Bid Addendum

Addendum No. 3 for the City of Staunton Johnson, Byers, and New Street Tunnel Repairs.

Addendum Date: November 10, 2025

CITY OF STAUNTON
JOHNSON, BYERS, AND NEW
STREET TUNNEL REPAIRS
STAUNTON, VIRGINIA

JOHNSON ST TUNNEL LAYOUT

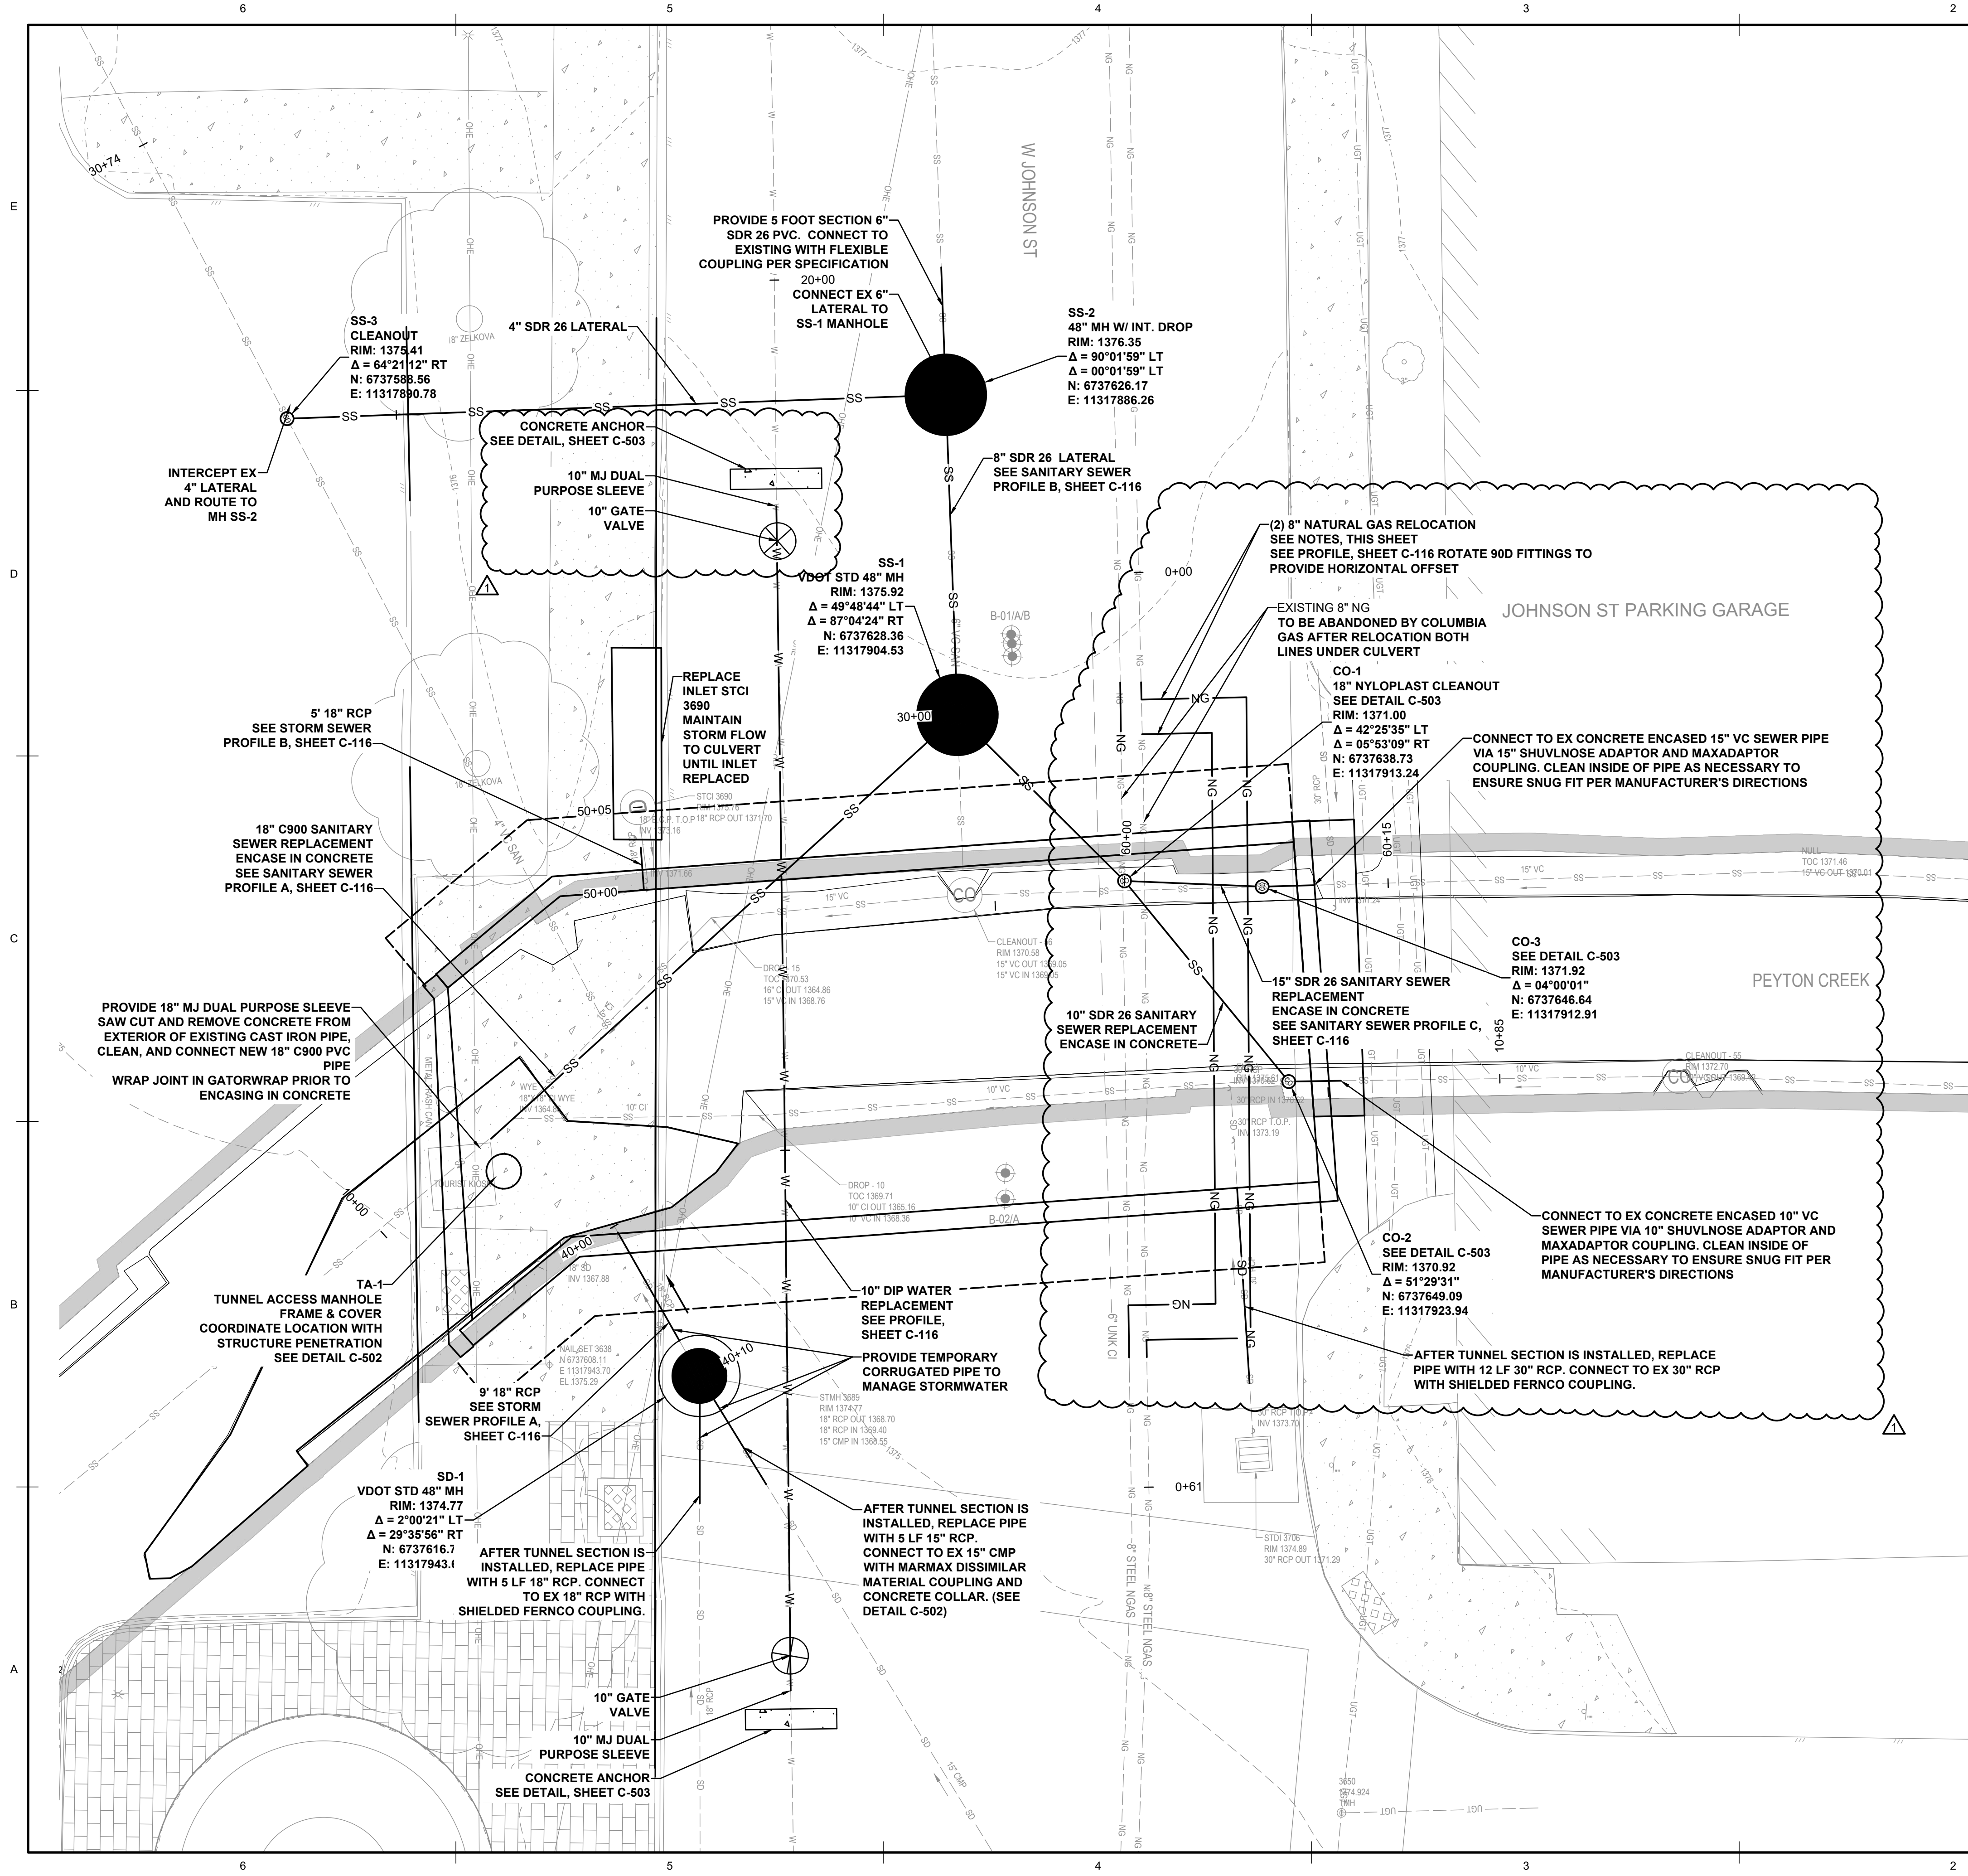
Drawing C-113: Has been reissued to show the ceiling only replacement and the reduced extents of tunnel replacement at the plan east end of the tunnel.

SHT. NO. C-114

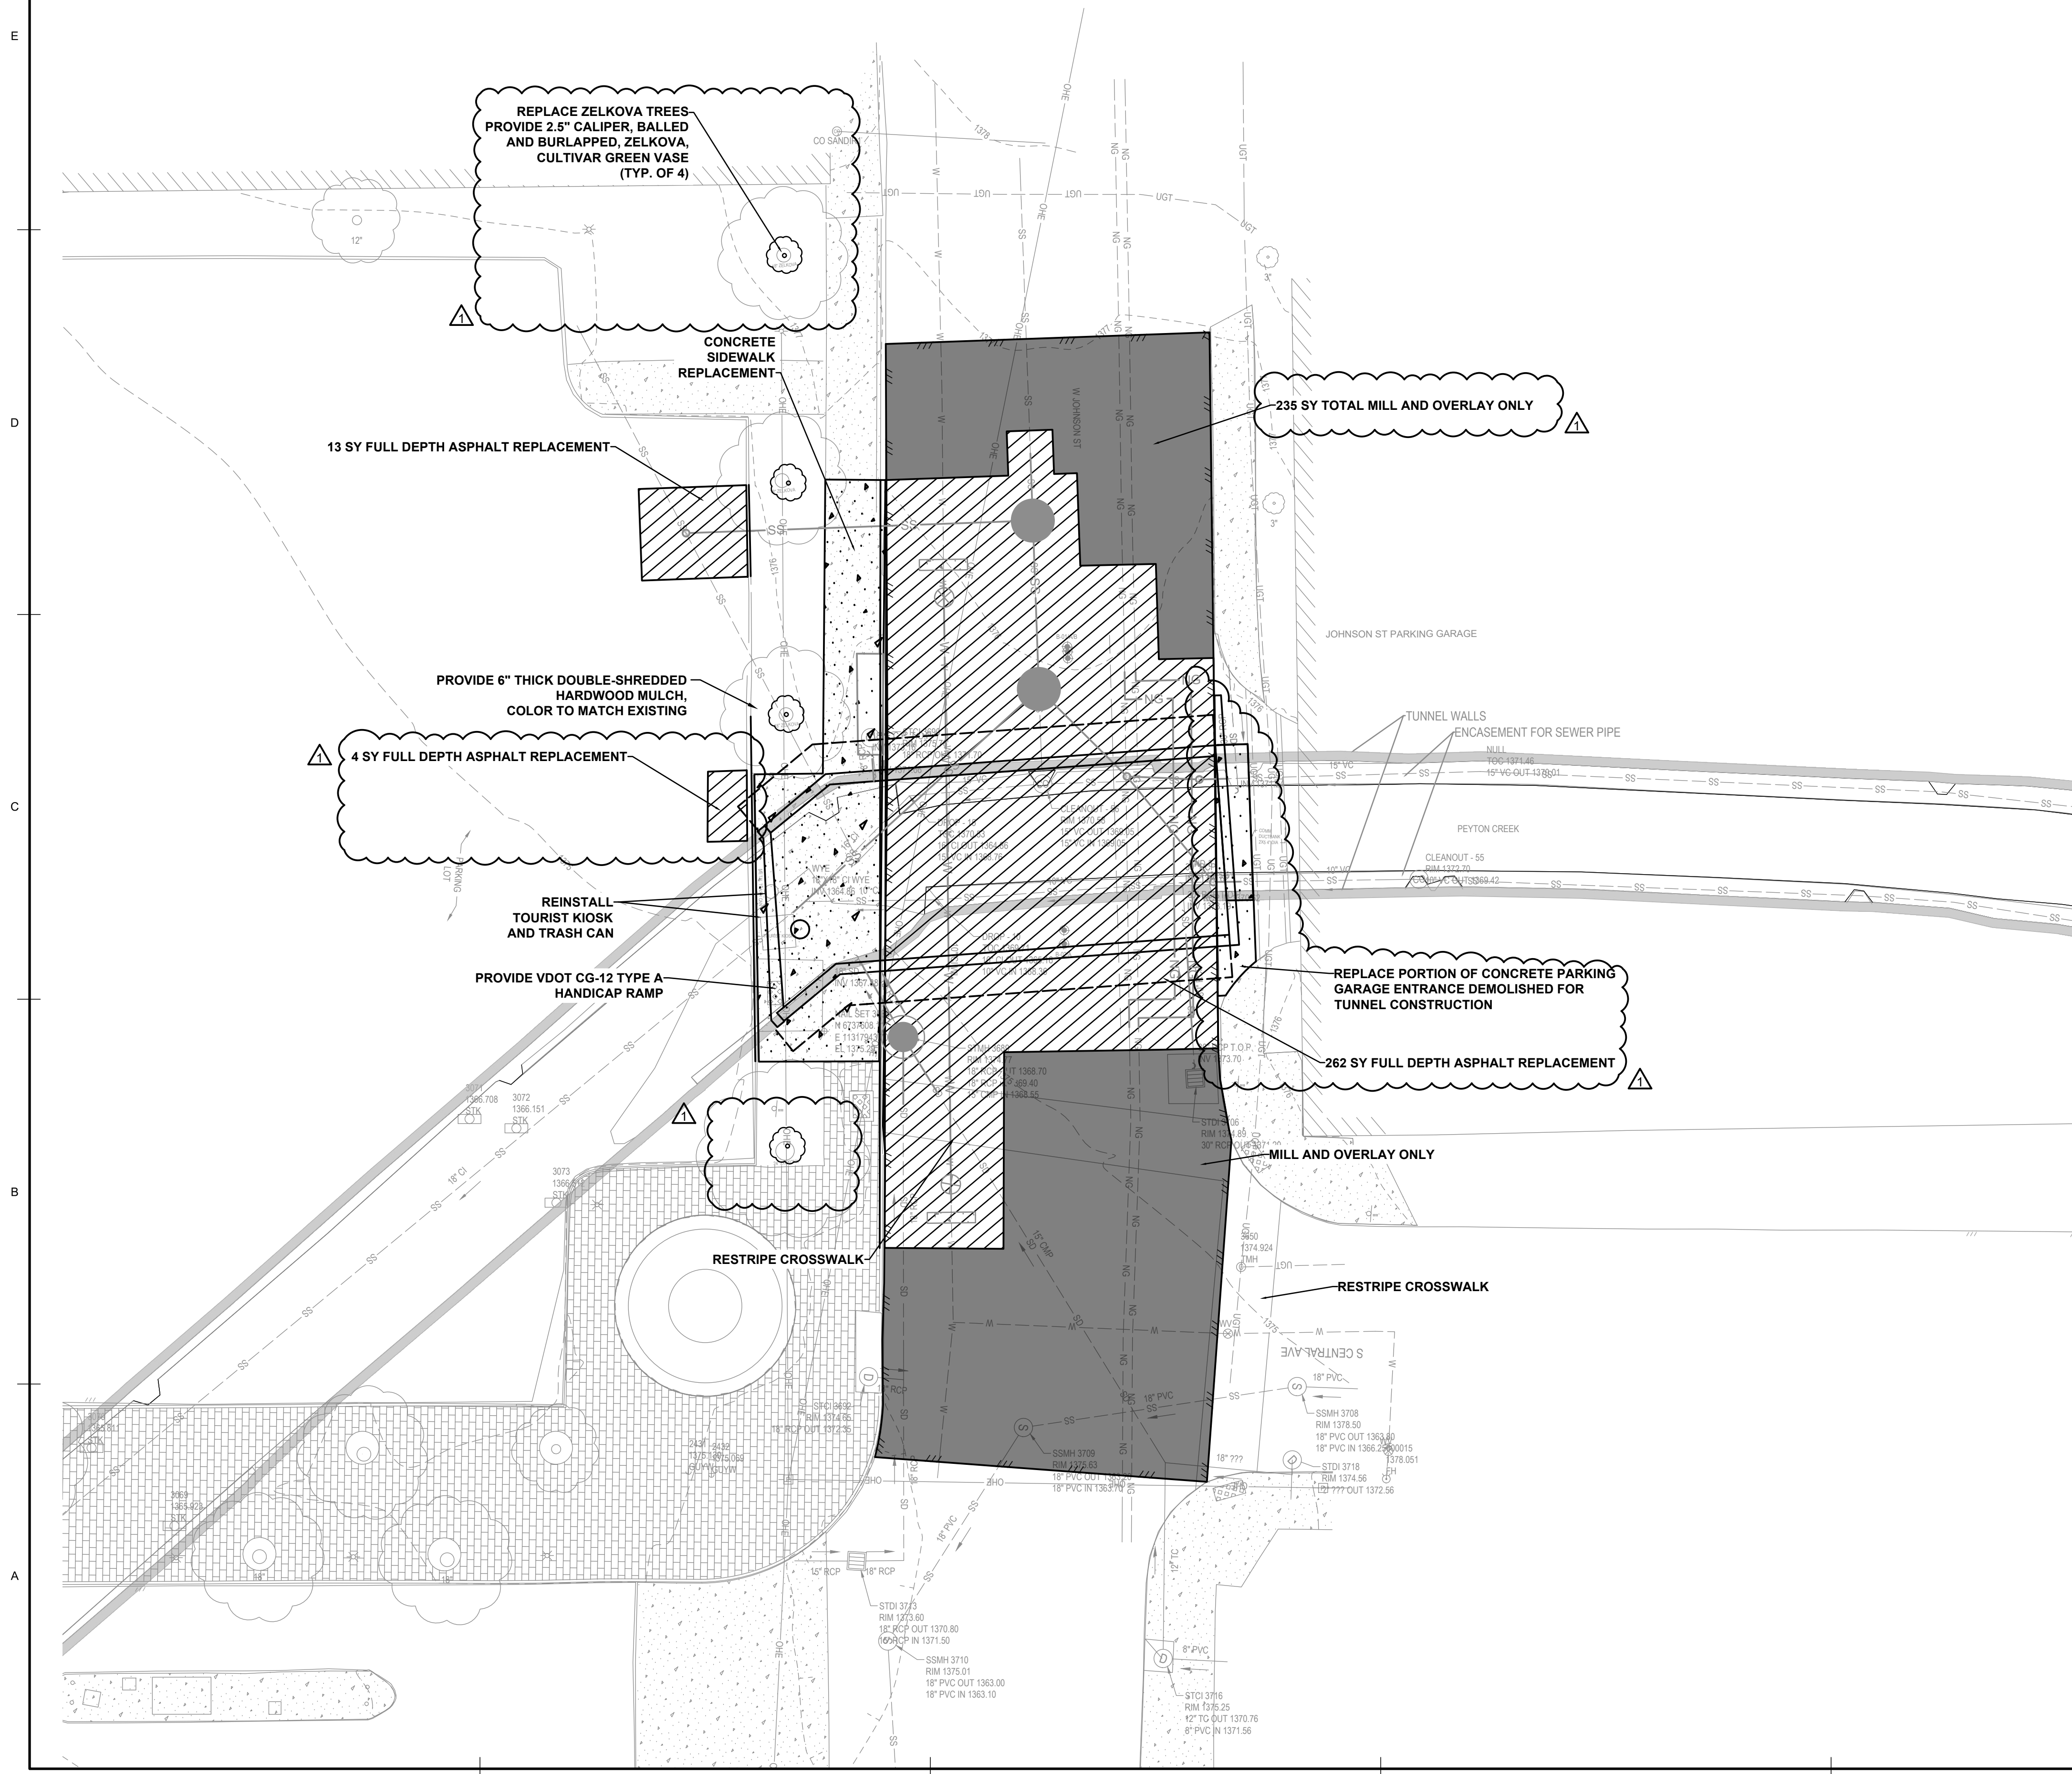
3. Note revised Sheet C-114 showing relocation of two gas lines.
-

Question 27: Note on plan sheet C-114 says this line is detailed as San Profile A on sheet C-116 but that is incorrect and no profile is given. Can profile for this sewer run be provided?

Drawing C-114: Has been reissued to show the addition of CO-3, modifications to CO-1 and CO-2, increase the length of 10” CI water line to be replaced, removal of the replacement of 8 LF of 30” RCP at the plan east end of the tunnel, relocation of two gas lines, and modifications to the notes section.

Response: San Profile A on C-116 shows from the connection of the new 18" C900 sanitary sewer pipe to the existing 18" CIP upstream to SS-1 to CO-1 to CO-2. The references on C-114 have been updated to reference C-116.

Response: We have revised how this pipe ties into the existing 15" VC. See revised sheets C-114 and C-116 (profile Sanitary Sewer Profile C) and details on C-503. As long as the encasement provides 5" minimum between the face of concrete and the outside of pipe, some overhang of the encasement past the footing is acceptable.

JOHNSON ST SURFACE IMPROVEMENTS

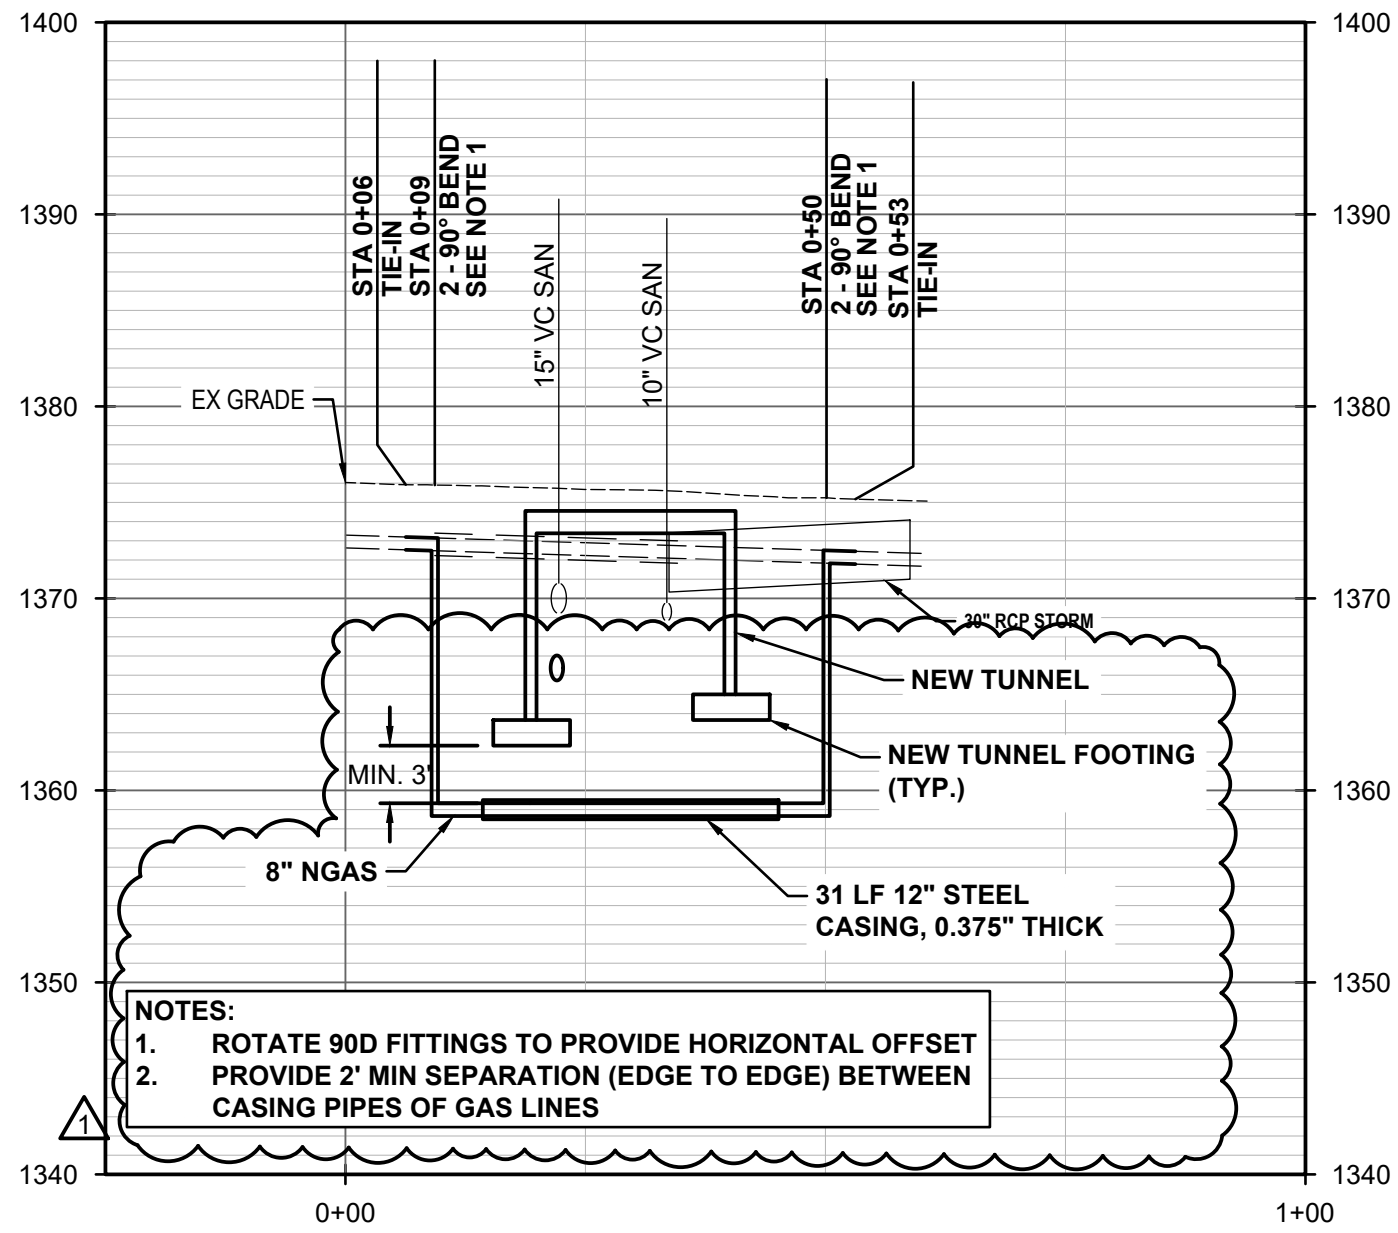
Drawing C-115: Has been reissued to show the replacement of two additional Zelkova trees, the reduced extent of surface restoration at the plan east of the tunnel, and updates to the surface restoration quantities.
